# PLANNING COMMISSION STAFF REPORT

# Country Club Acres Amended Plat of Blocks 11 to 18

Subdivision Amendment – Preliminary Plat PLNSUB2012-00017 2268 Country Club Drive Hearing date: March 14, 2012

# **EXHIBIT A**Preliminary Plat

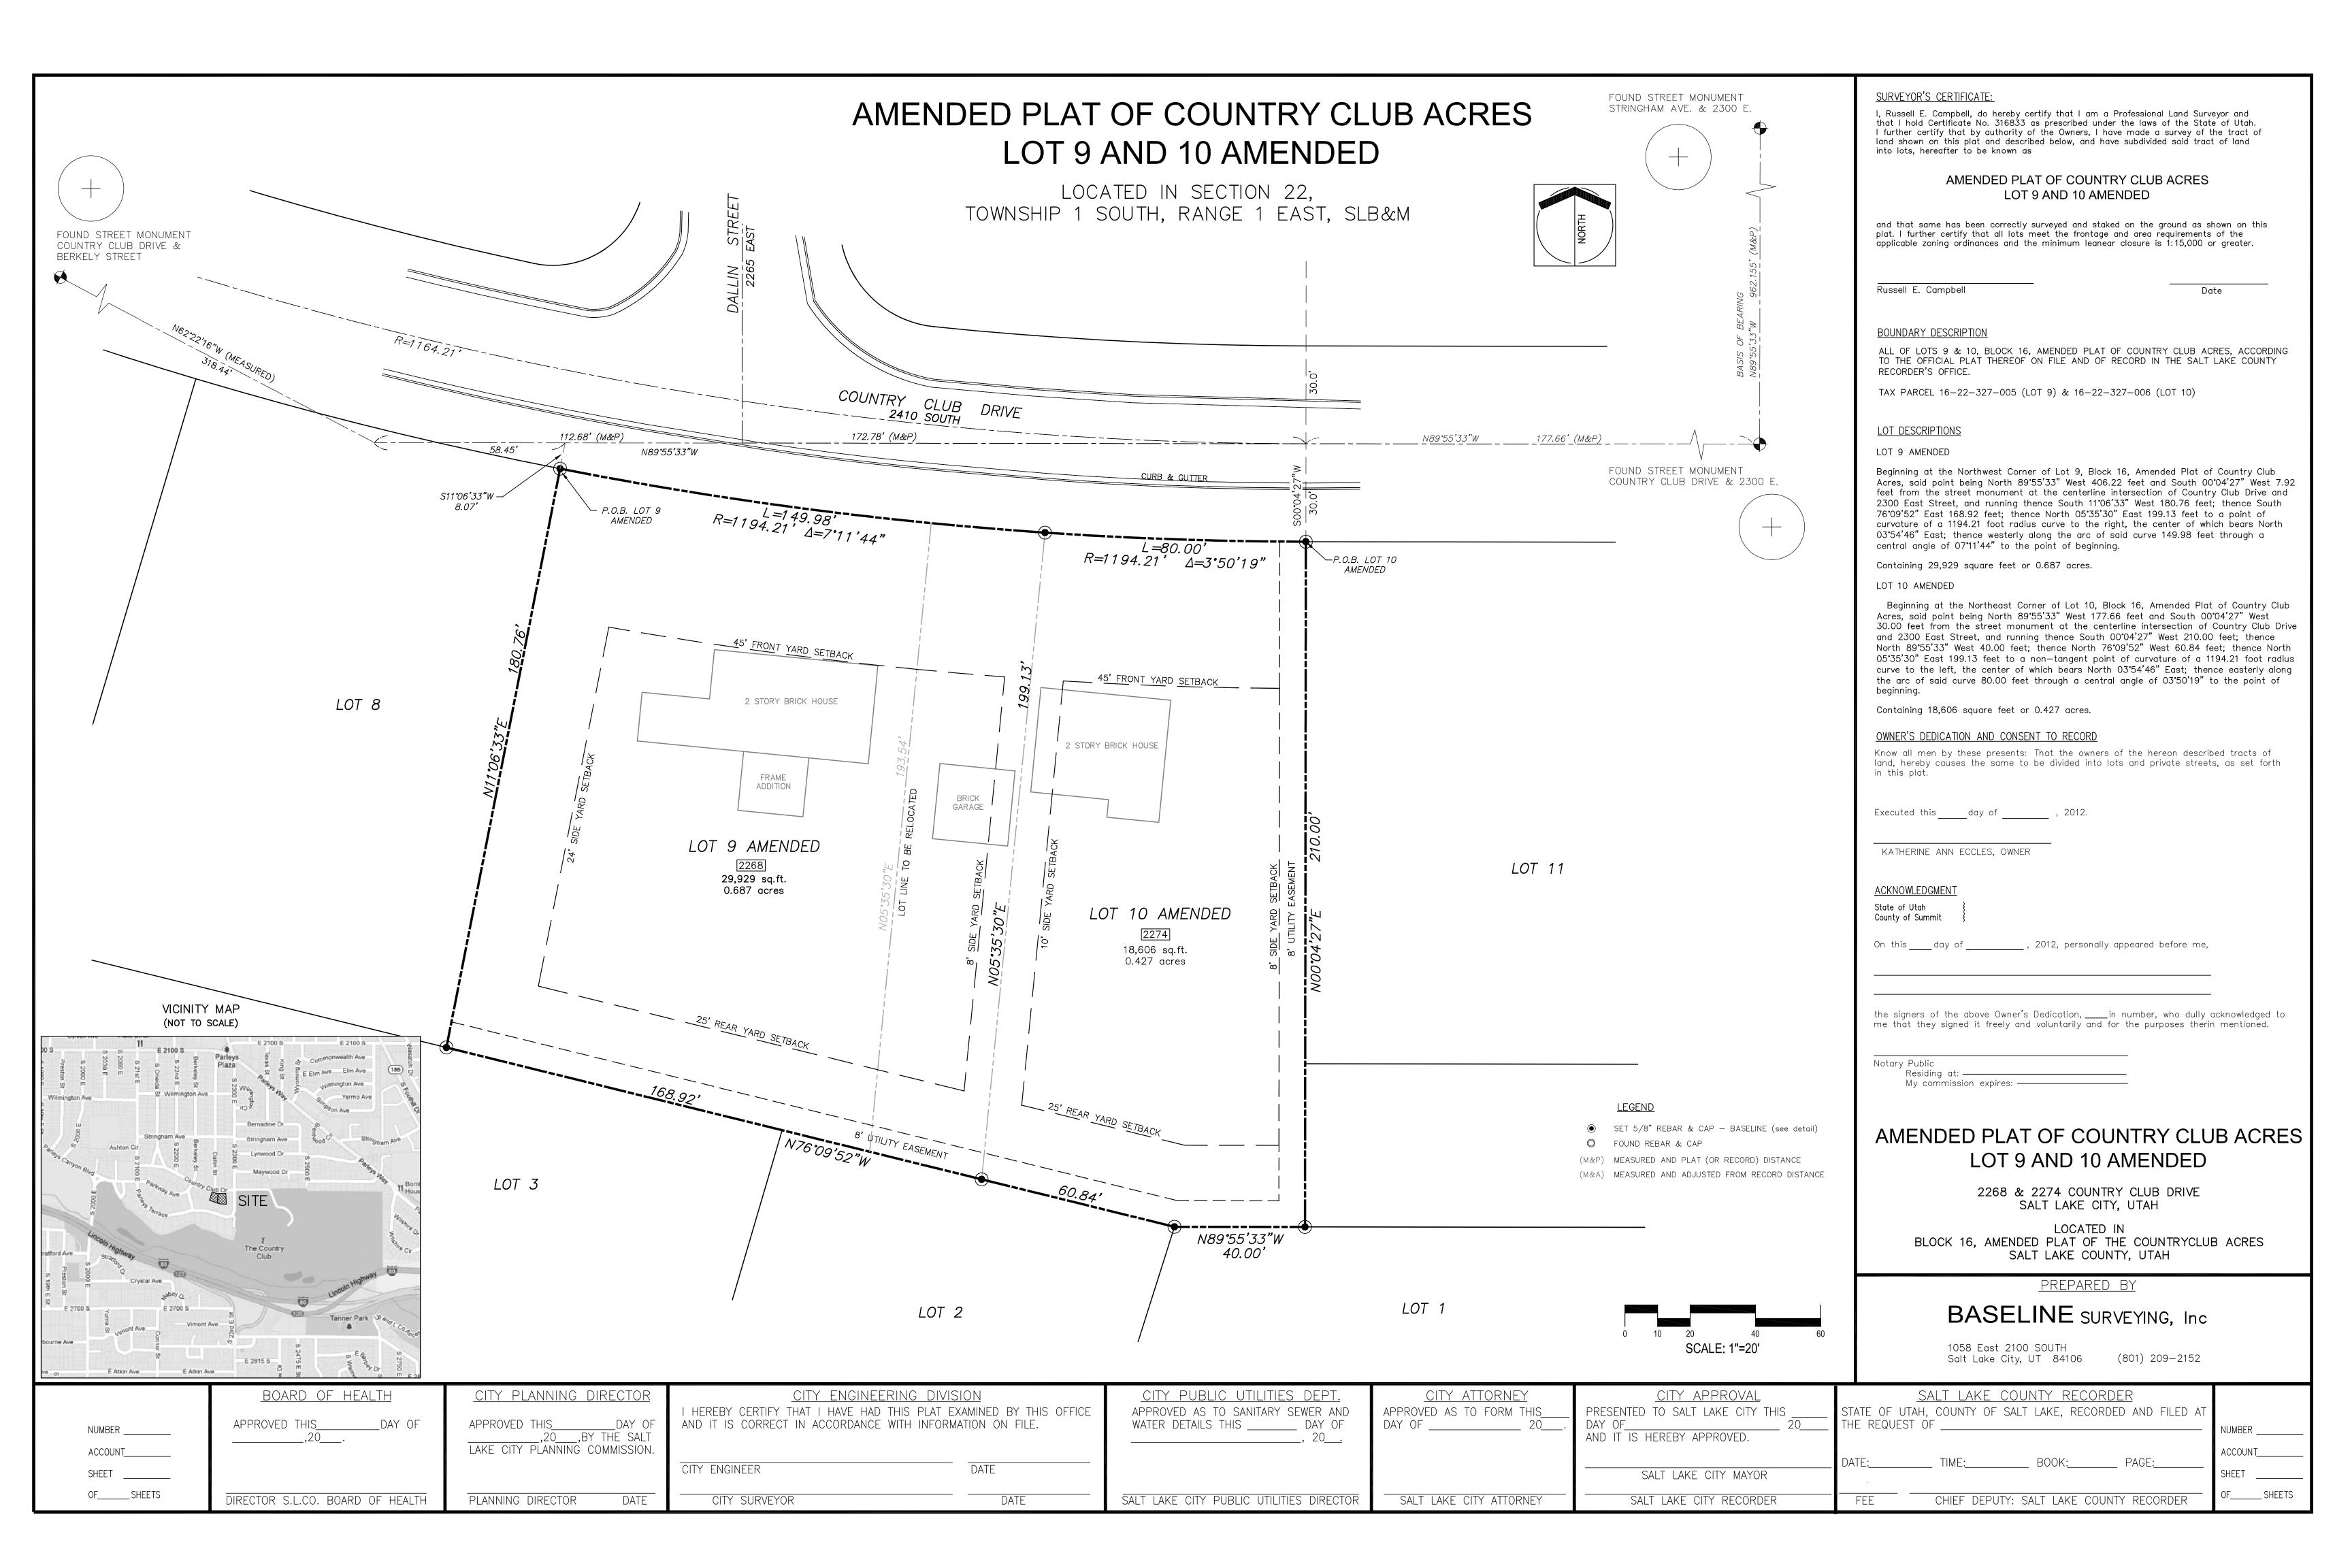
The home at 2268 E would continue to meet the zoning standards and would not need to be demolished before recording of the final plat. However, the associated accessory structure shown on the proposed plat will need to be demolished prior to recording of the final plat so as to not violate the 8 foot side yard setback requirement of the zoning district, as well as the accessory structure requirements of 21A.36.020B and 21A.40.050. Any other existing accessory structures which also violate the setback requirements of the proposed plats will need to be removed prior to recording of the final plat.

The initial plat review has been completed. Redlined comments on the plat have been sent directly to Baseline Surveying, requiring corrections and resubmittal of the plat. The condition of the existing gutter at the drive approach for 2268 E Country Club Drive is very bad. The gutter must be replaced as part of this project.
